Neils report on
voice mod. for TA-1.

28 February 1957

General: TA-1 Transmitter
 Specific: Modulator (Project 2515)

FIG. I
PRESENT CIRCUIT OF TA-1 MODULATOR

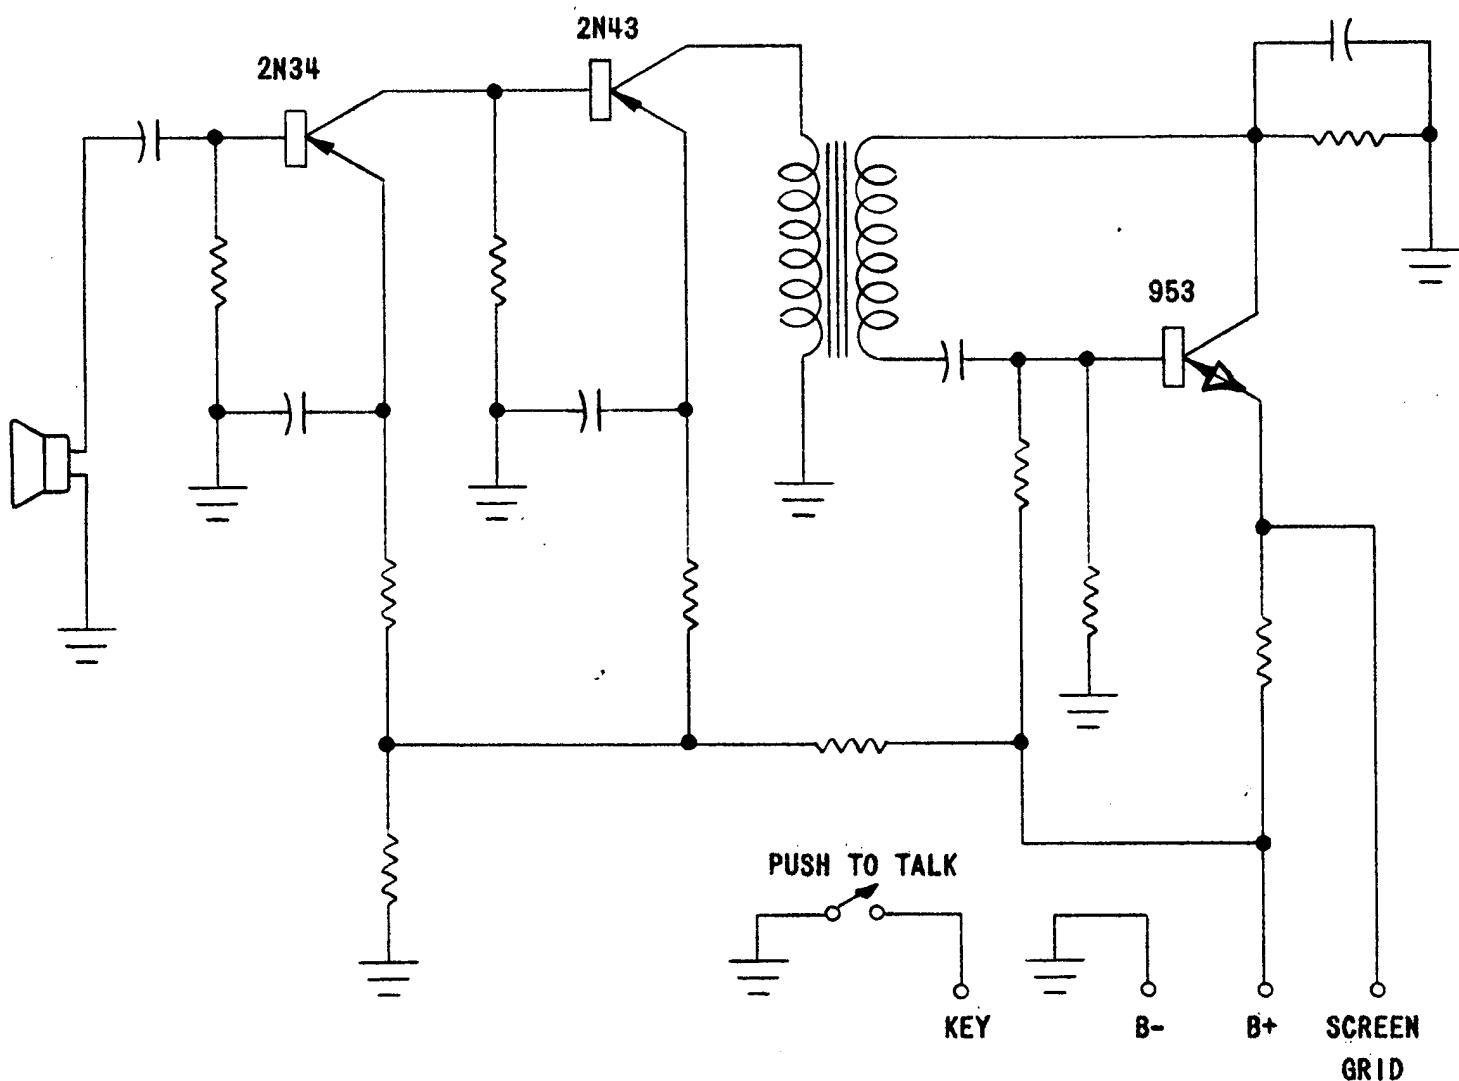
TRANSMITTAL SLIP		DATE March 18/57
TO: <i>Neil</i>		
ROOM NO.	BUILDING	
REMARKS: <i>Neil please comment on Para 2 of your report How can we correct or get around this situation.</i>		
<i>ATB</i>		
<i>Please return</i>		
FROM:		
ROOM NO.	BUILDING	EXTENSION

Figure 1 in the appendix shows the circuit developed. This circuit performed satisfactorily but has one serious fault. If the transmitter tube is removed or the filament opens, the transistor (953) might be damaged due to the increase in collector voltage.

The more satisfactory way to modulate the transmitter is to create a separate modulator unit. A separate unit creates no hazard to the final transistor; its installation is simple enough so that a field station could adapt it to existing TA-1 transmitters.

FIG. 2
PROPOSED CIRCUIT FOR TA-1 MODULATOR

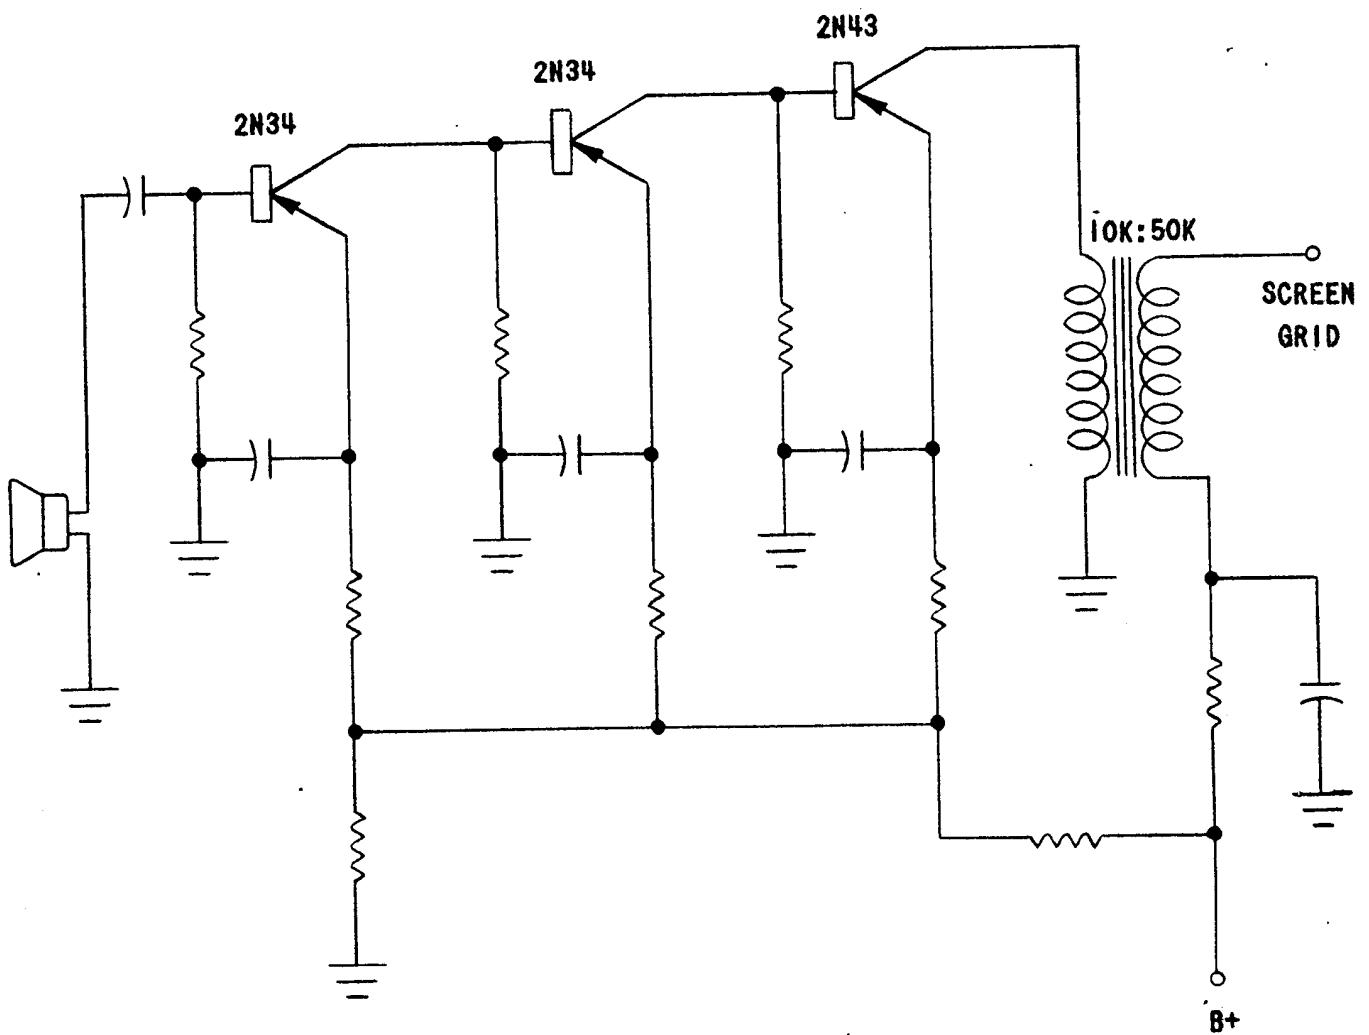
The modulator may be made as a separate unit. The circuit shown in Figure 2 should modulate the transmitter 60 to 75 percent. Two power cables would be necessary. One cable would be used for [redacted] and the other cable for phone operation. Modifications on TA-1 transmitters now in the field could be made without any difficulty. A separate modulator unit would not appreciably increase the weight or size of the completed unit.
